## Access Compliance Report Public Rights-of-Way (Curb Ramps)

Intersection ID: 10023486Main Street: CIRCUMFERENTIAL\_RDCross Street: N/ALocation:NWADA ID: 480C9589DDA9Ramp Type: Directional1Initial Pass/Fail: PassOverall Compliance: NoSeverity Score:17.5

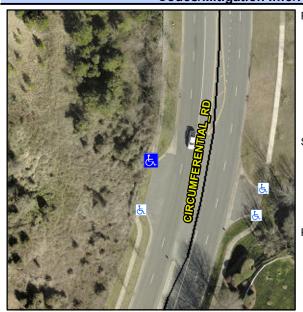
Comp	liance Description	Data	Comp	oliance Description	Data
N/A	Ramp Length (in)	29.0	Yes	Grade Break?	Yes
Yes	Ramp Width (in)	58.0	Yes	Grade Break Slope (%)	0.2
Yes	Ramp Slope (%)	0.2	Yes	Grade Break XSlope (%)	0.8
Yes	Ramp XSlope (%)	0.4			
N/A	Flare Type LT	N/A	N/A	Flare Type RT	N/A
N/A	Flare Slope LT (%)	N/A	N/A	Flare Slope RT (%)	N/A
N/A	Flare Traversable LT?	N/A	N/A	Flare Traversable RT?	N/A
Yes	Landing Length (in)	51.0	Yes	DWS Provided?	Yes
Yes	Landing Width (in)	58.0	Yes	DWS Contrast?	Yes
Yes	Landing Slope (%)	2.0	Yes	DWS Length (in)	24.0
No	Landing X Slope (%)	2.3	No	DWS Full Width?	No
N/A	Landing Curb? (Y/N)	No	Yes	DWS Offset LT (in)	1.0
N/A	Shared Landing?	No	Yes	DWS Offset RT (in)	0.5
Yes	Gutter Ponding?	No	Yes	Gutter Slope (%)	1.2
No	Gutter Lip Ht (in)	1.0	No	Gutter X Slope (%)	2.6
N/A	Painted X Walk1?	No		Road Slope (%)	0.4
	X Walk 1 Direction	To S		Road X Slope (%)	2.1
	X Walk 1 Width (in)	N/A		Clear Space?	Yes

X Walk 1 Slope (%)	0.4	N/A	Clear Space to XWalk (in)	N/A
	X Walk 1 X Slope (%)	2.1	Yes	Storm Grate/Utility Hazard?	No
N/A	Ramp inside XWalk1?	N/A		Storm Grate/Utility Type	
Yes	Any Obstructions?	No			N/A
	Obstruction Type		Yes	Surface Condition? (G/P)	Good
		N/A	No	Curb Slope (%)	9.9

Possible Solutions:	
Remove & Replace Entire Ramp. Remove & Replace Gutter.	
	,
Surveyor Natae	
Surveyor Notes:	,
N/A	,
	,
PROW/ADA:	
Not Found, R304.5.3, R305.1.4,	
R302.7.2
